UNITED STATES PATENT AND TRADEMARK OFFICE
CERTIFICATE OF CORRECTION

PATENT NO. : 6,906,961 B2
APPLICATION NO. : 10/602991
DATED : June 14, 2005
INVENTOR(S) : Eggleston et al.

Fig. 6B

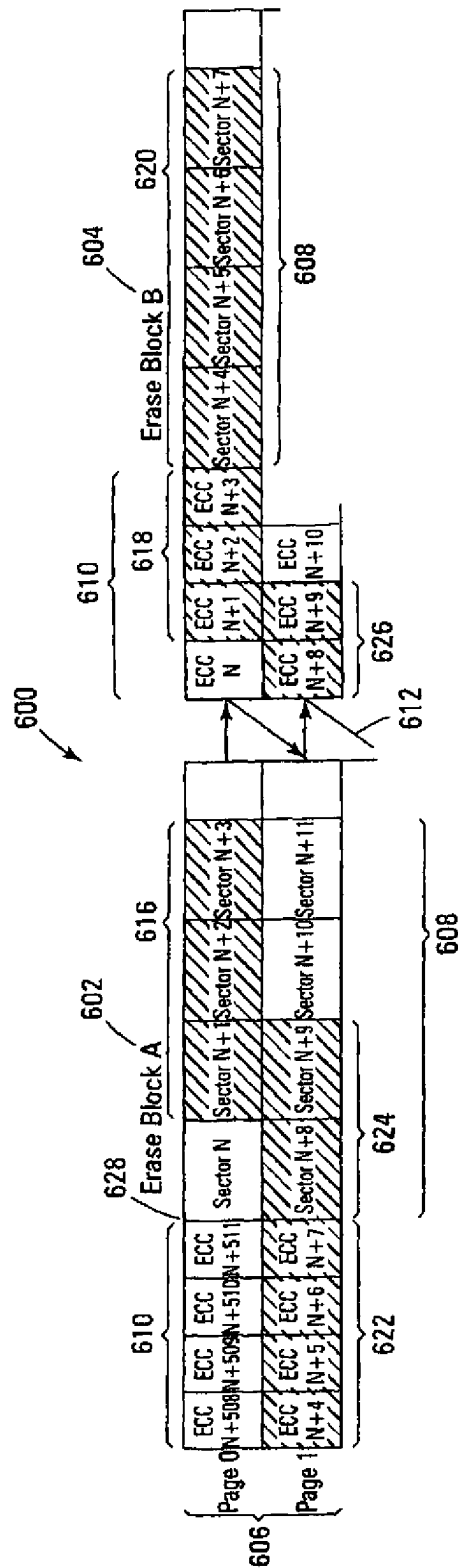
At sheet 9 of 12, delete Figure 6B and replace with attached Replacement Figure 6B.
